MIL-E-23001/3D(AS)
AMENDMENT 1
25 March 1977

MILITARY SPECIFICATION SHEET

ELECTRIC GENERATING SYSTEM, AIRCRAFT, VSCF
20 KVA, 115/200 VOLT, 3-PHASE, 400 Hz

This amendment forms a part of Military Specification Sheet MIL-E-23001/3D(AS), dated 25 July 1975.

Figure 1

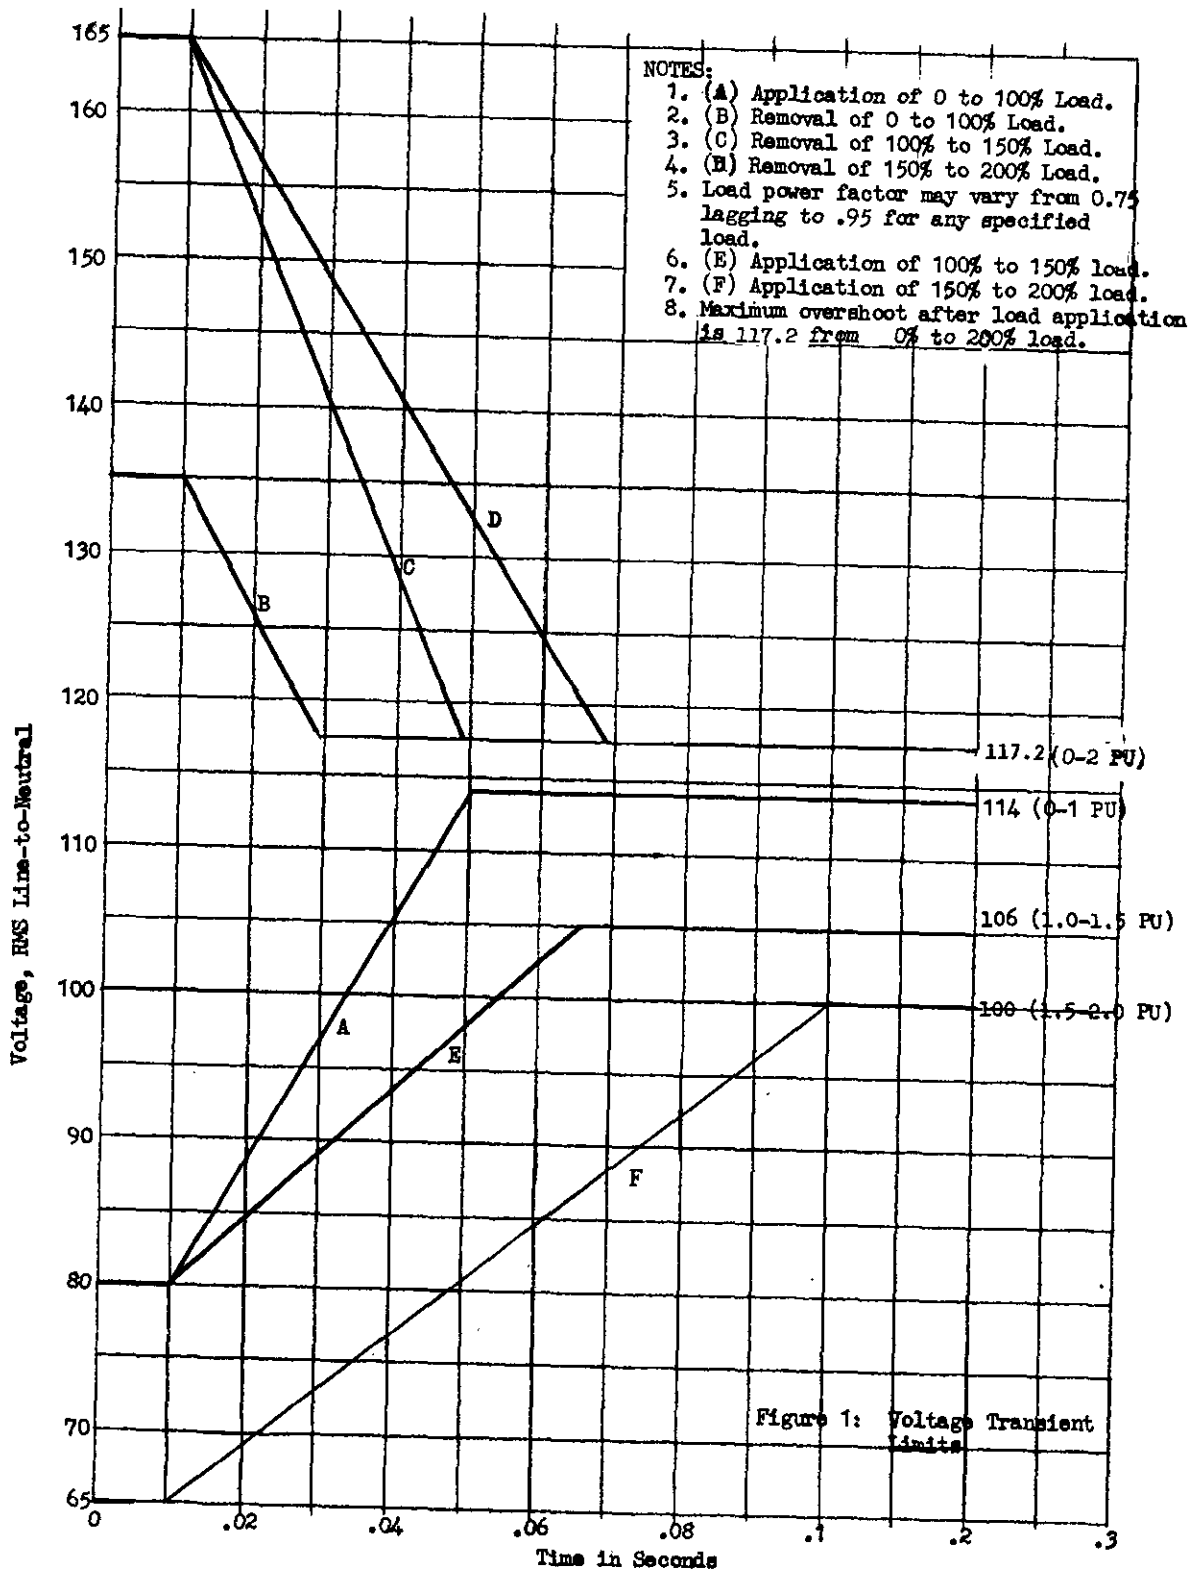
3.2.2 Add: "Curve F of Figure 1 of this amendment shall be modified to be zero volts from 0 to 2 seconds, after which time it goes directly to 100 volts."

Delete and substitute Figure 1 of this amendment.

Figure 5
Filter Characteristic
for measuring
Voltage and Frequency
Modulation

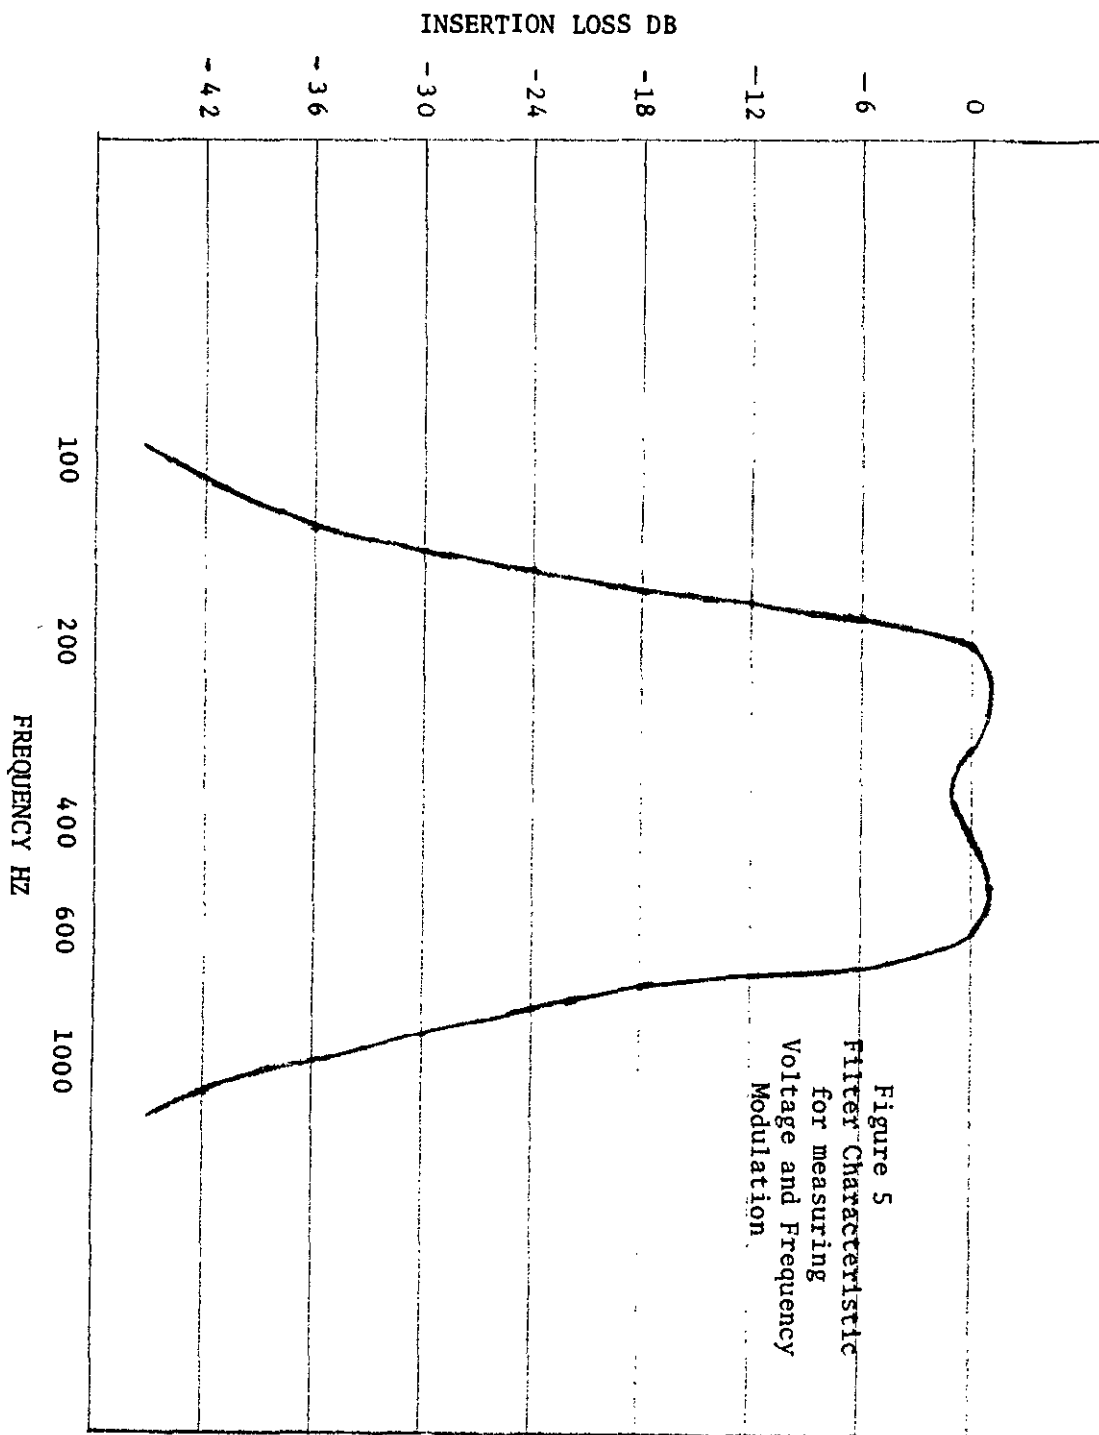
Add: 4.5.9 Voltage Modulation, Frequency Modulation, and Waveform. Delete "low-pass" and substitute "band-pass" in second sentence. Delete Figure 5 and substitute Figure 5 of this amendment.

Add 6.2.9 True Voltage Modulation. Delete "low-pass filter having a cut off frequency of 600 Hz" substitute "band pass filter having an insertion loss of less than one (1) db between 200 and 600 Hz."

Add: 6.2.11 True Frequency Modulation. Delete: "low-pass filter having a cut off frequency of 600 Hz" substitute "band pass filter having an insertion loss of less than one (1) db between 200 and 600 Hz."
